McKinley High School – Construction Documents
800 E McKinley St, Baton Rouge, LA 70802
Domain Chasm Project No. C24-0038/24009

ADDENDUM NO. 2

A4.711

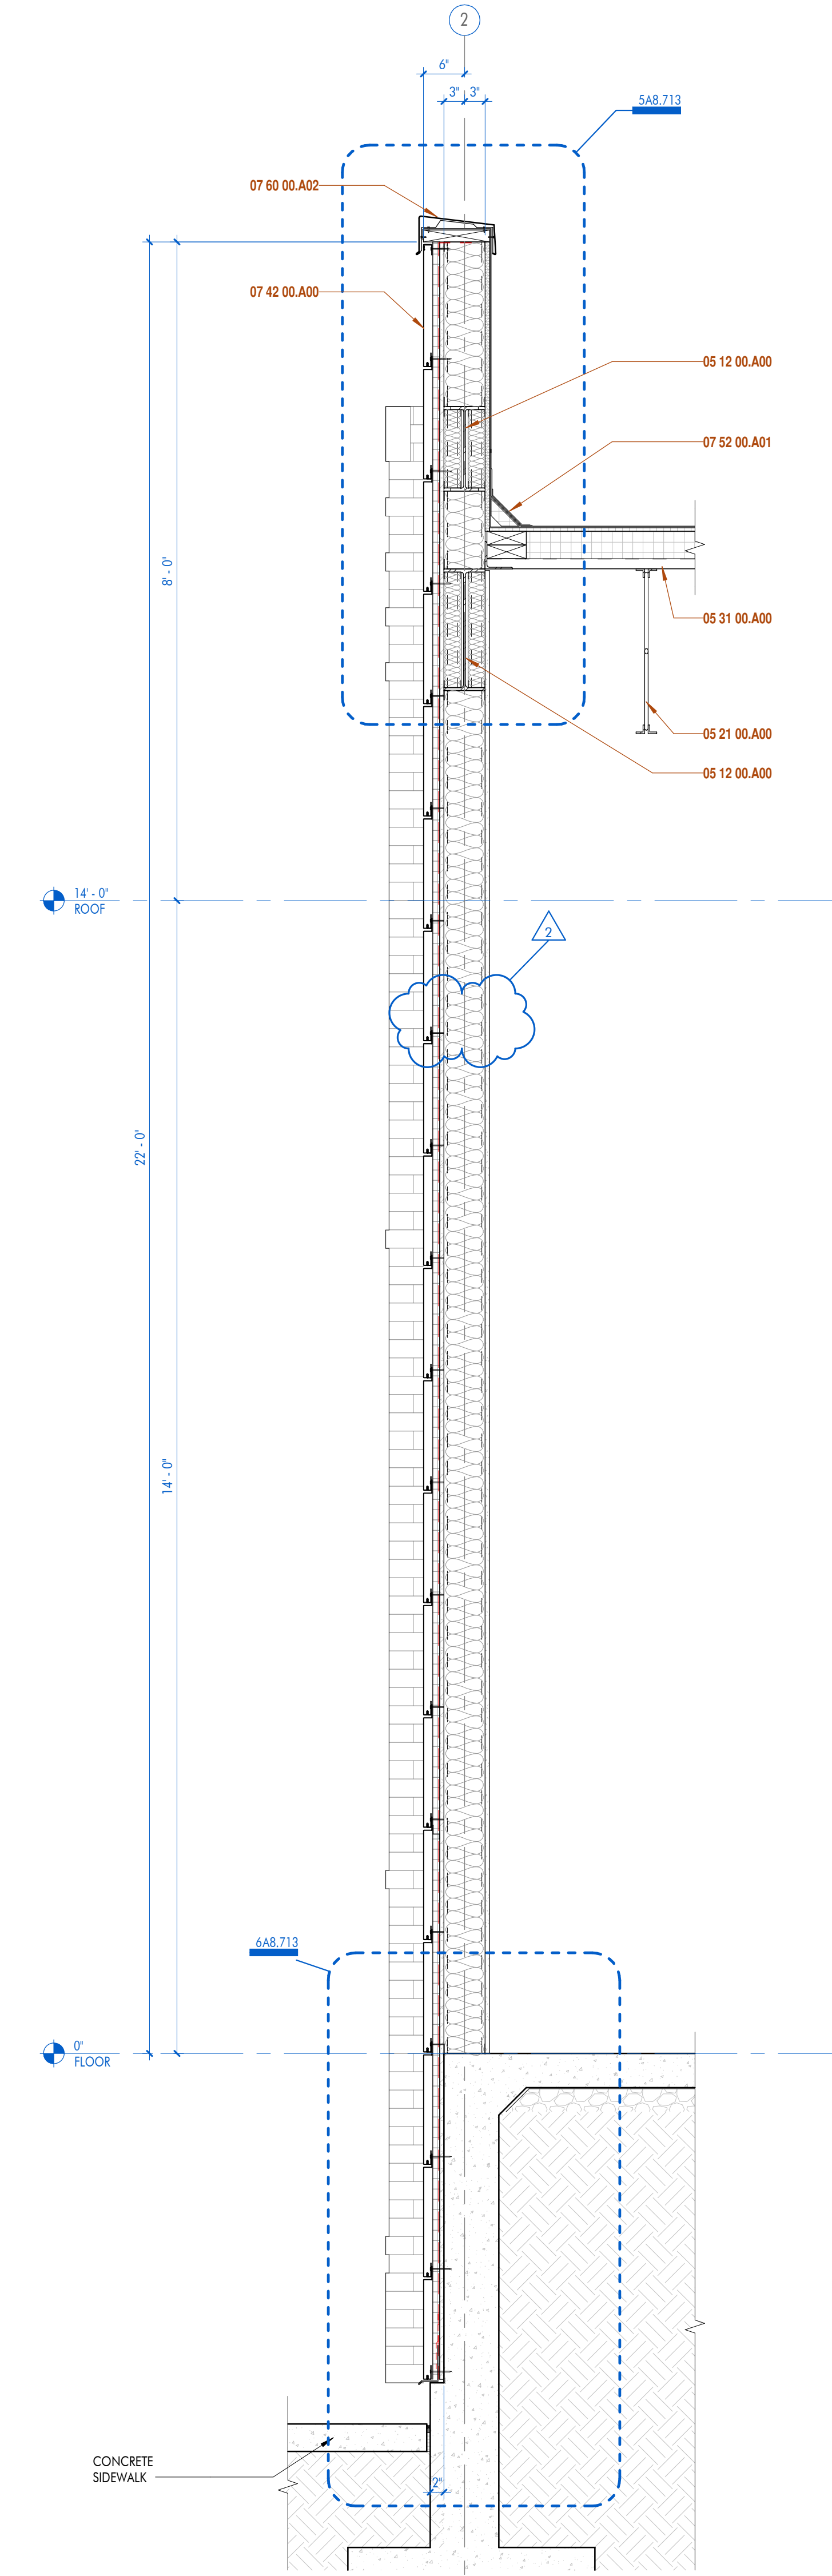
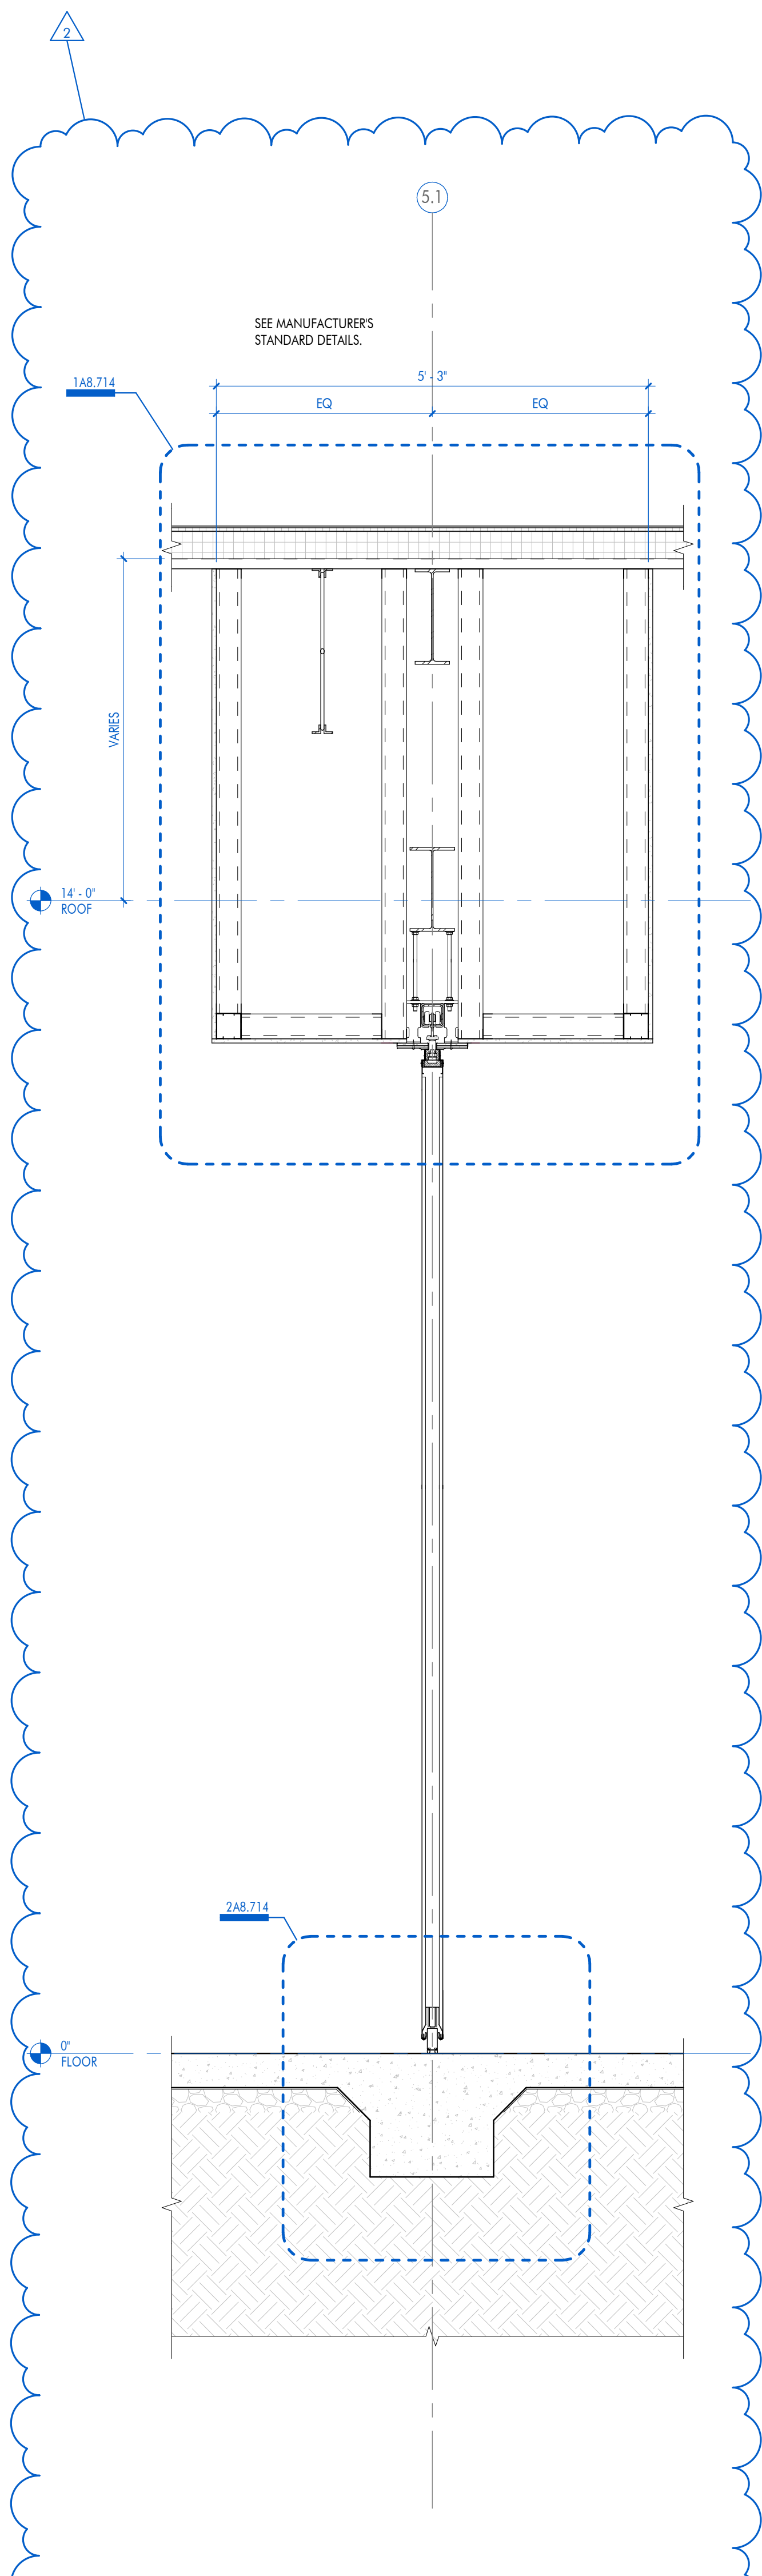
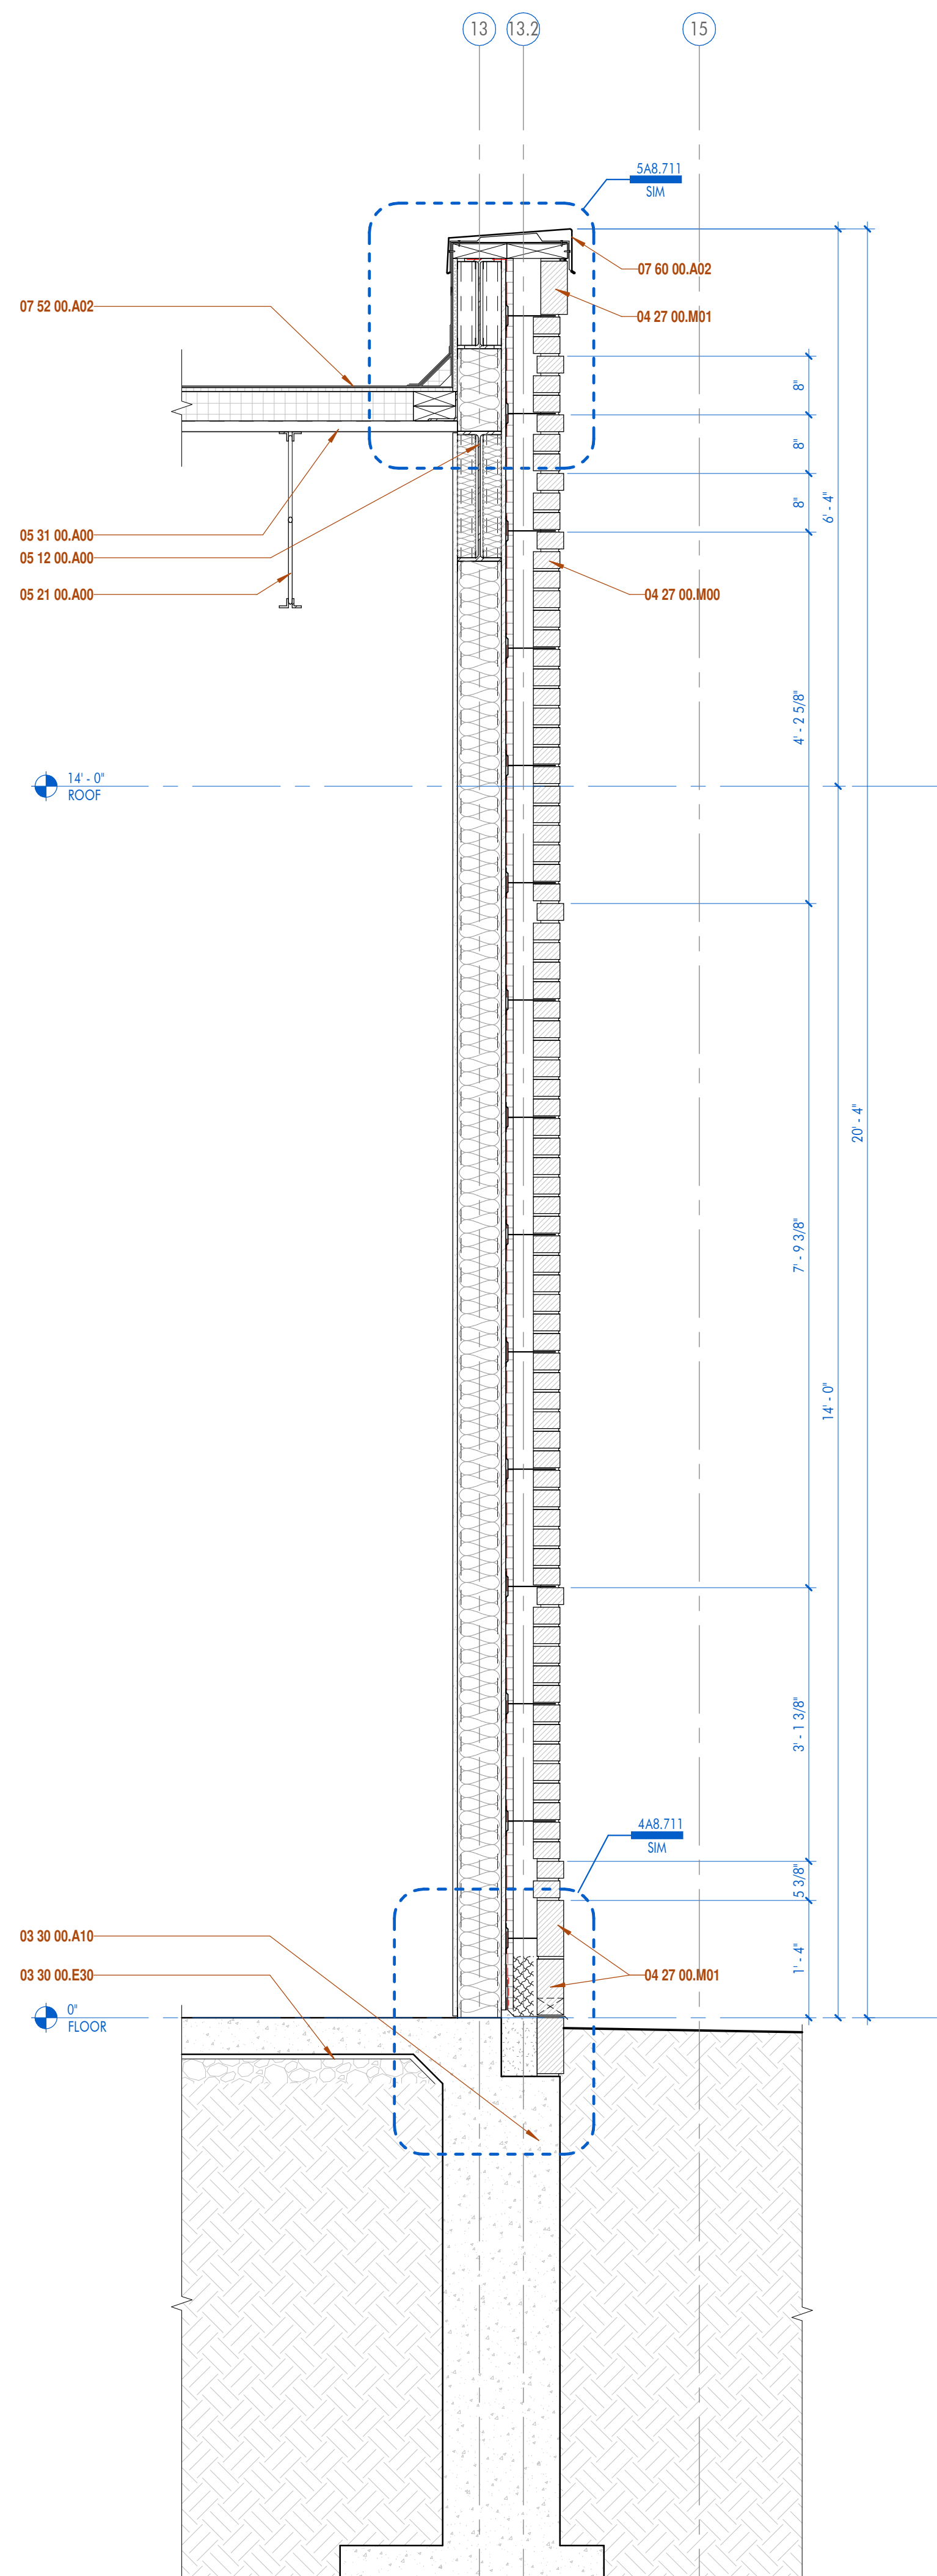
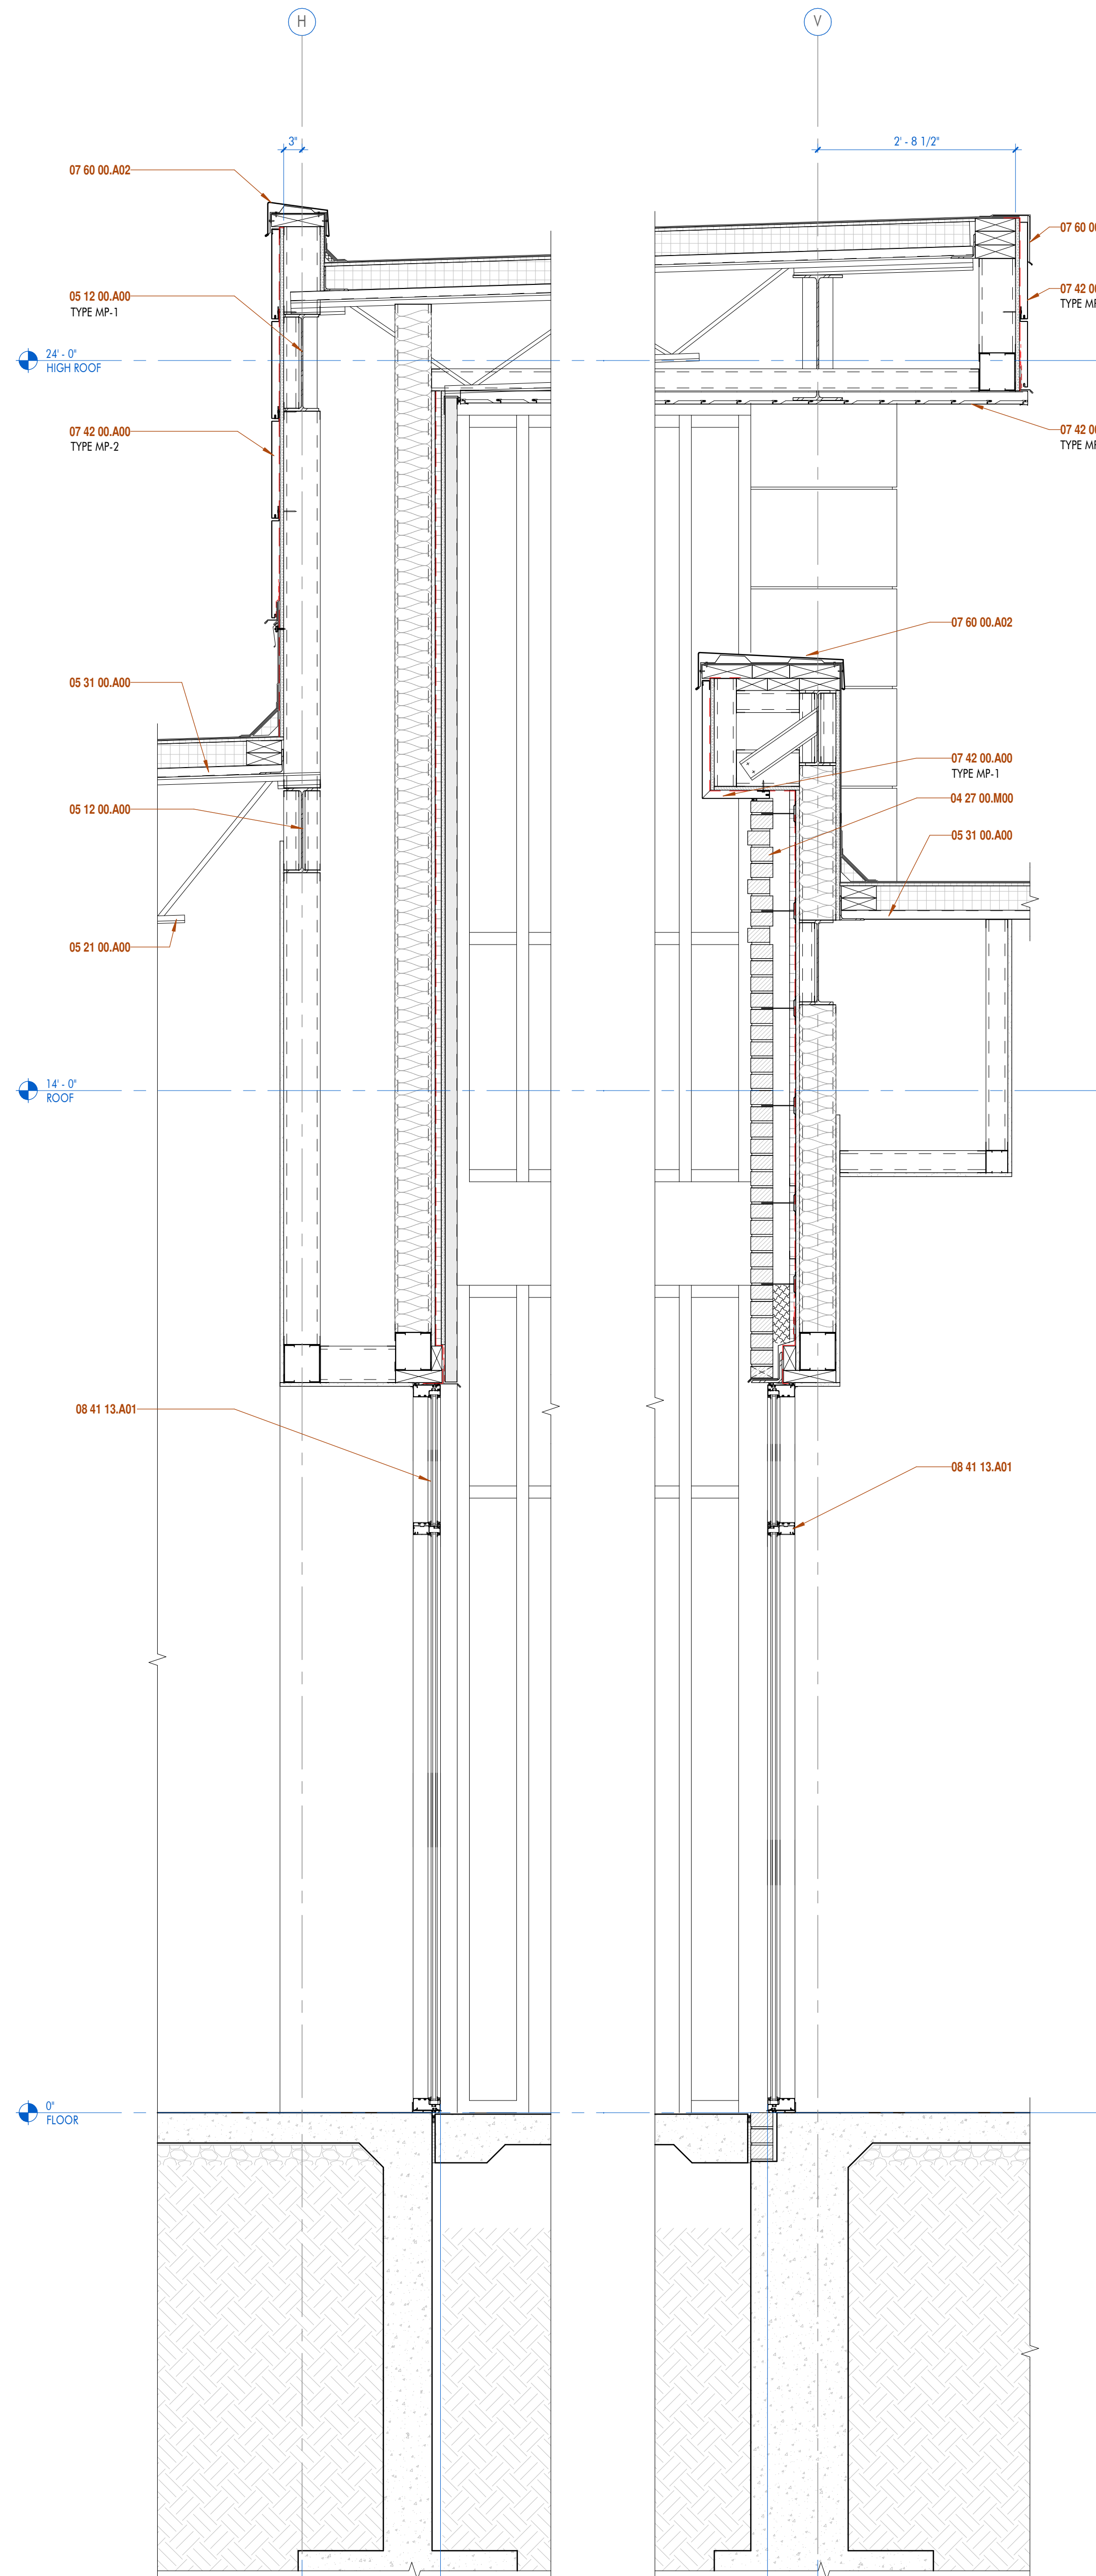
10. Sheet A10.304 – Millwork Details – BLDG. C – Replace previously issued sheet with revised attached sheet.
11. Sheet A4.711 – Window Elevations – New Arts Bldg. - Added detail references to several window frame elevations. Remove previously issued sheet and replace sheet with revised attached sheet.
